RE: Sharon W.S.C.
Application to Amend Water CCN (10476)
PWS ID# 2500020
Upshur County, Texas.
Docket #44816 – Order No. 4

SHARON W.S.C.
CCN AMENDMENT APPLICATION
WOOD COUNTY, TEXAS

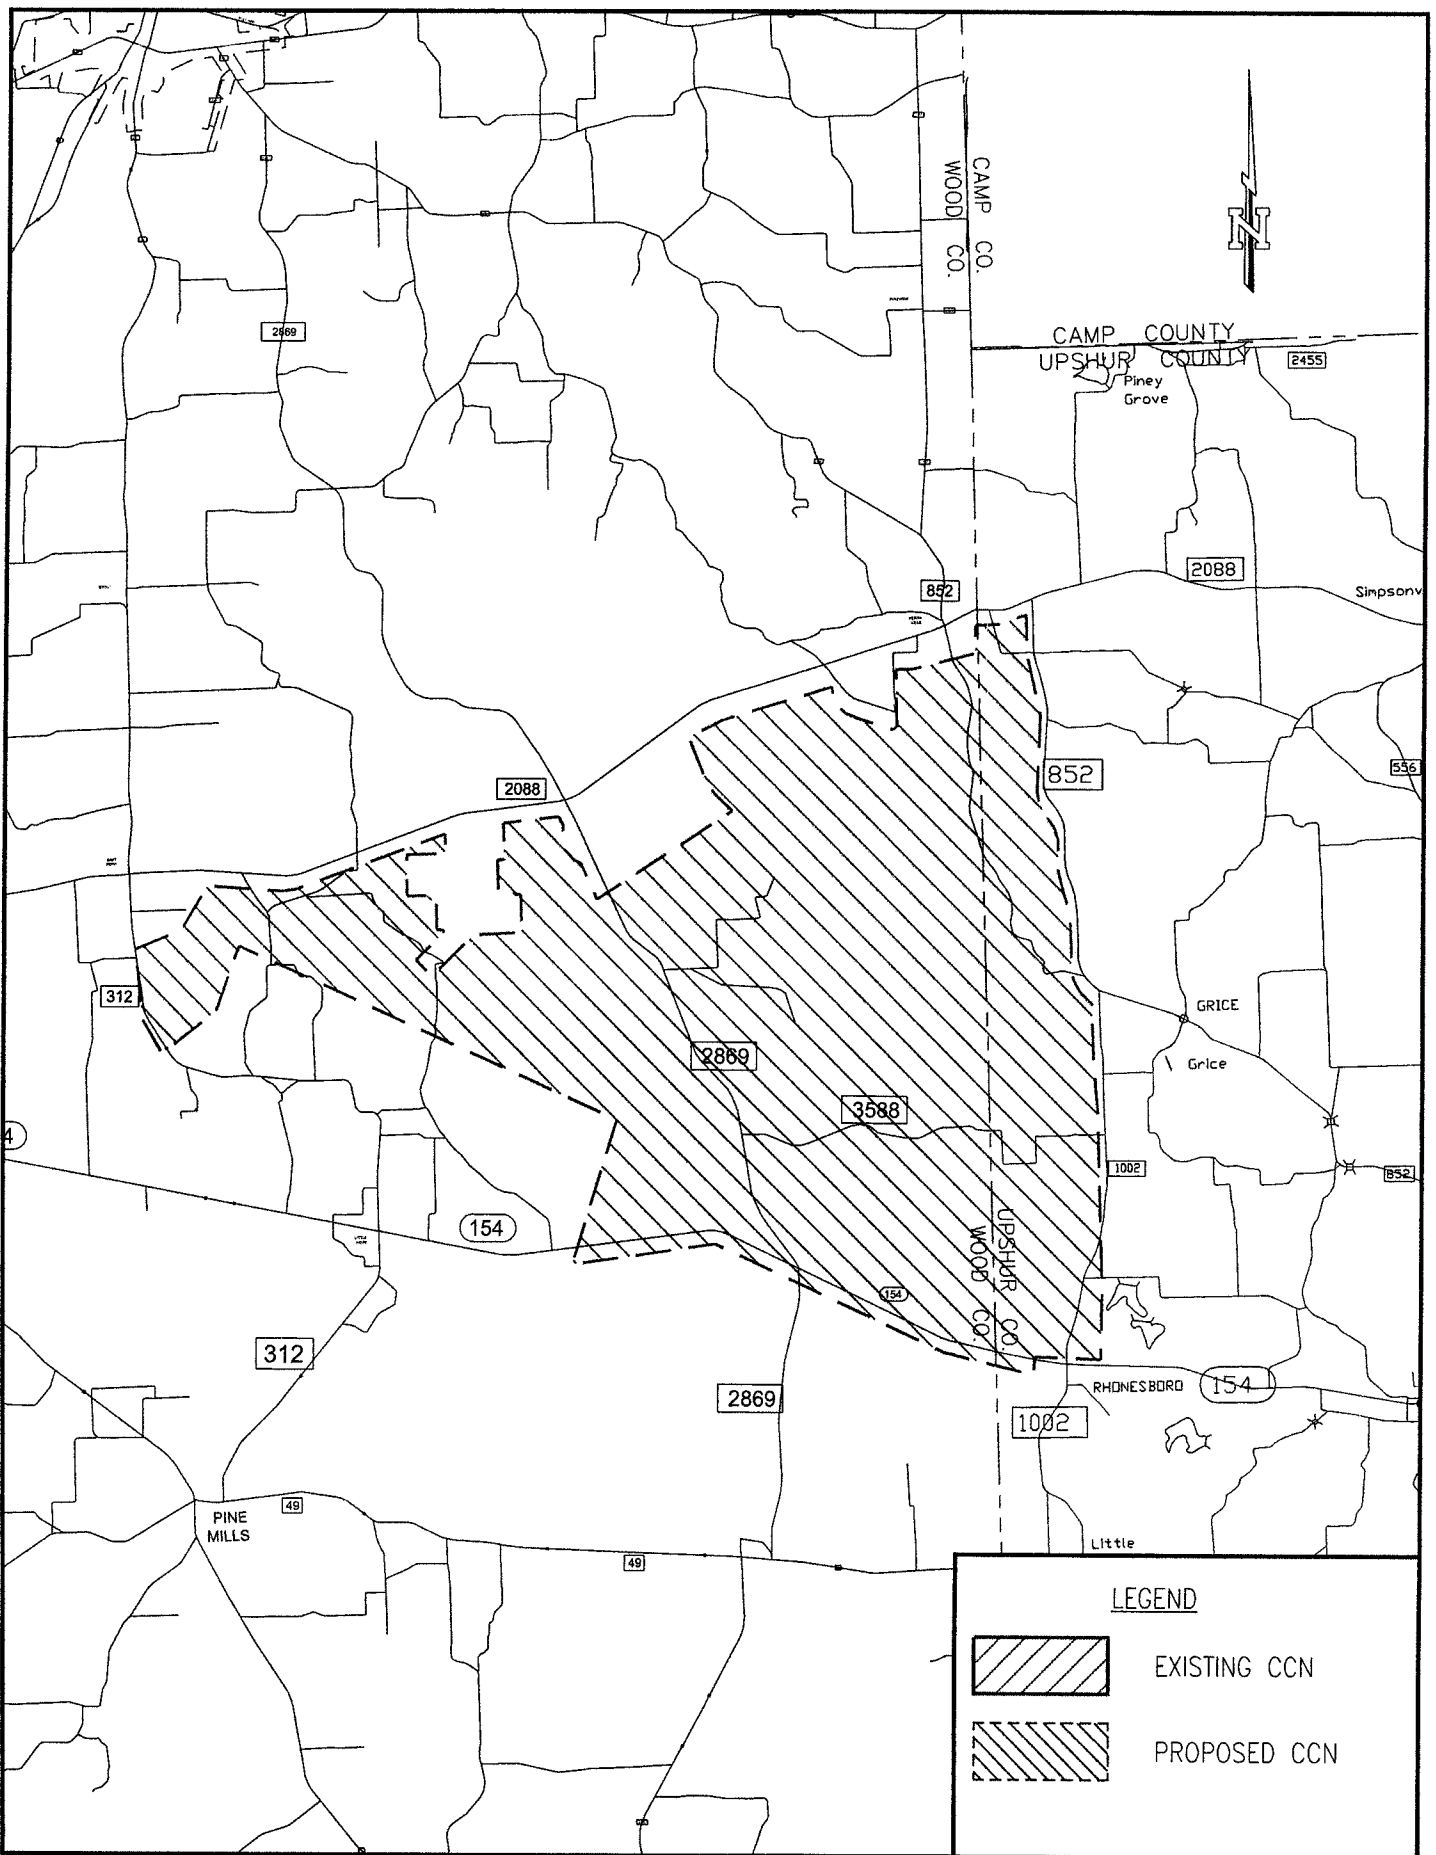
- 1.) A general location (small scale) map showing only the proposed water service area with enough detail to accurately locate the service area within Upshur and Wood Counties.

- a. **A small scale location map has been attached**
- 2.) A large scale (detail) map only showing the proposed water service area with enough detail to accurately locate the service area in the vicinity of surrounding roads, streets, and highways.
